The United States of America National Report for the Convention on Nuclear Safety

Answers to Questions From the Peer
Review By Contracting Parties

April 2002

Figure 1: Reactor Oversight Process Framework

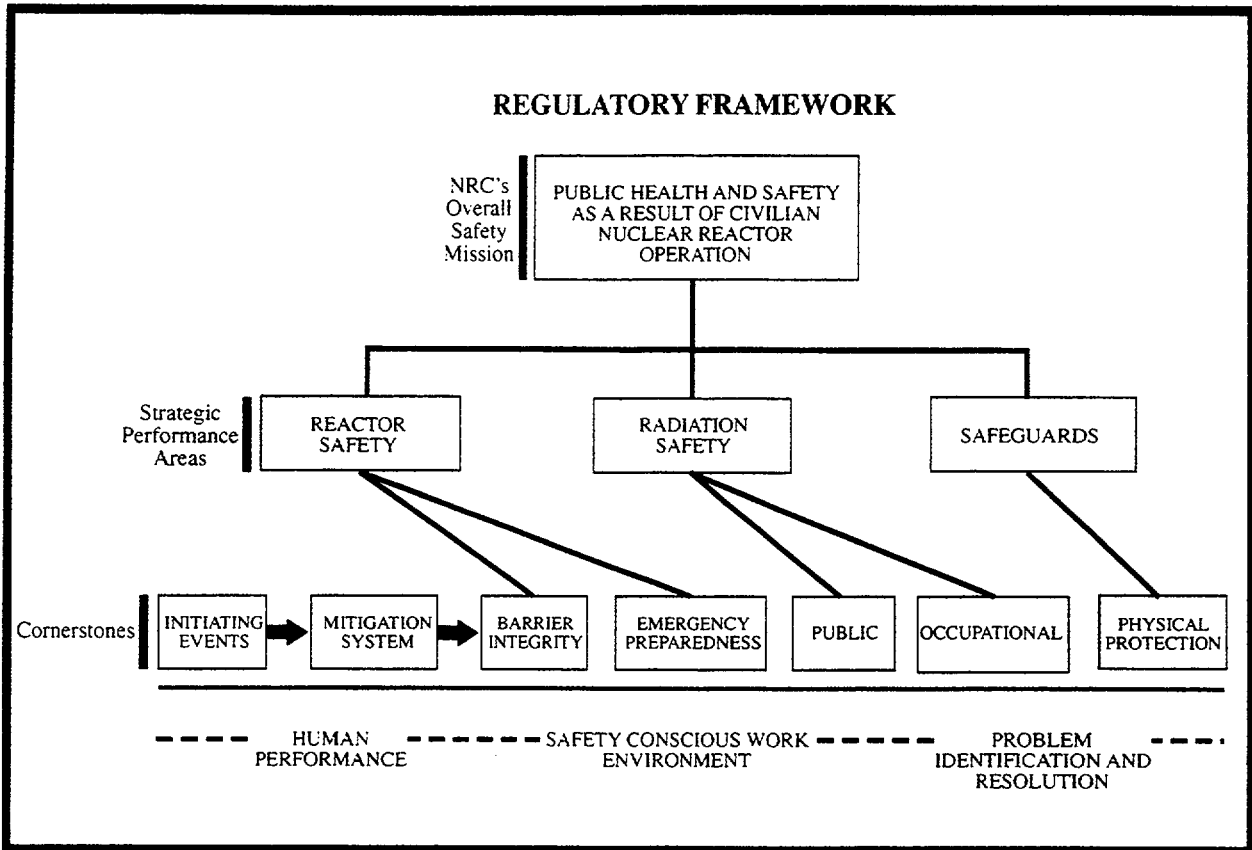
Question: The framework of ROP (Figure-1) consists of the performance indicator (PI) and the base-line inspection. And as a supplementary, you proposed "cross-cut" items such as: Human performance Safety-conscious work environment Problem identification and resolution. It might be more difficult to evaluate these " cross-cut " items in comparison to the PIs and BLIs. [i.e., baseline inspections] What kind of plan do you have for development?

Answer: NRC has no plan for changing our evaluation of the crosscutting elements. To ensure adequate performance in each cornerstone area, the crosscutting elements are considered and where possible, linked to performance indicators or inspection areas.
